**A RESOLUTION APPROVING CHANGE ORDER #4 IN THE AMOUNT OF \$3,783.70
FOR THE HERBERT HOOVER HIGHWAY ROUNDABOUT PROJECT.**

Change Order Details

LFM-HHH3-RAB--7X-52

Description Herbert Hoover Highway and Johnson Cedar Road Roundabout

HERBERT HOOVER HWY & JOHNSON CEDAR RD ROUNDABOUT
 PCC JOINT REVISION EXHIBIT

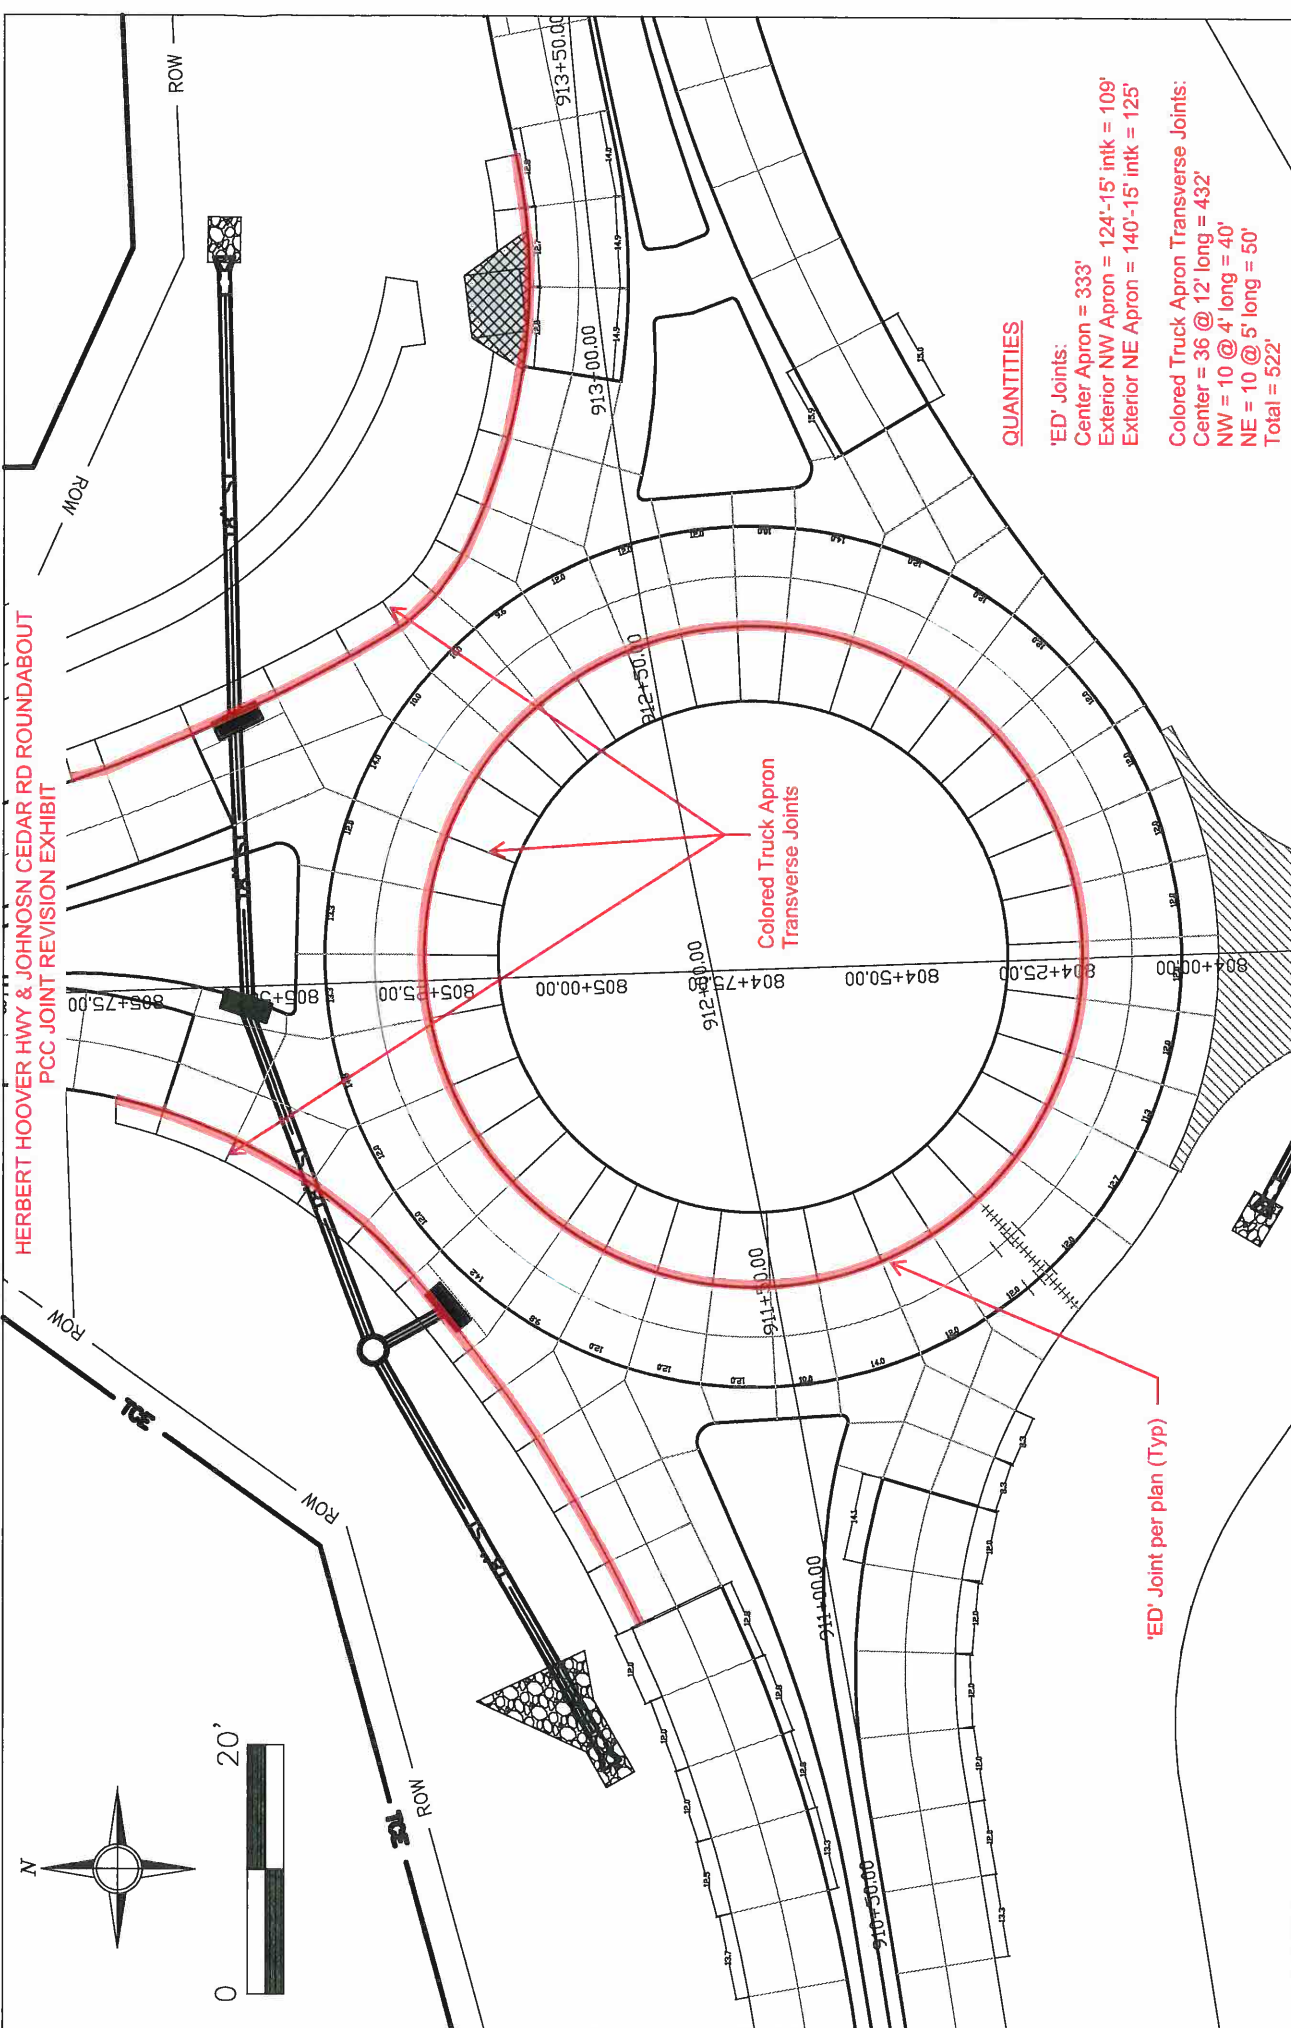
8005 Change: Add item for PCC Joint Revision. Longitudinal 'ED' joints at the interior truck apron will be changed to a 'BT' joint, longitudinal 'ED' joints at the exterior truck aprons will be modified to be installed using 3/4" diameter dowels at 18" centers, and Transverse 'C' joints for all aprons to be changed to 'CD' joints. Refer to Standard Road Plan PV-101 and the attached PCC Joint Revision Exhibit. The modified 'ED' joint installed with this change order will replace the #4 bars shown for installation at the back of curb in the sidewalk dowel detail along (refer to

construction plan sheet S.01).

8005 Change: Contracting authority desires to change the type of joint that is used at the longitudinal joints that connect the colored truck aprons to the mainline pavement and at the transverse joints of the colored truck aprons.

1. Change interior longitudinal truck apron joint from 'ED' to 'BT' = -\$2,452.00
2. Change exterior longitudinal truck apron joint from 'ED' to modified 'ED' = -\$538.00
3. Change transverse truck apron joints from 'C' to 'CD' = \$8,273.00

- 'ED' Joints:
 Center Apron = 333'
 Exterior NW Apron = 124'-15" intk = 109'
 Exterior NE Apron = 140'-15" intk = 125'
- Colored Truck Apron Transverse Joints:
 Center = 36 @ 12' long = 432'
 NW = 10 @ 4' long = 40'
 NE = 10 @ 5' long = 50'
 Total = 522'

'ED' Joint per plan (Typ)
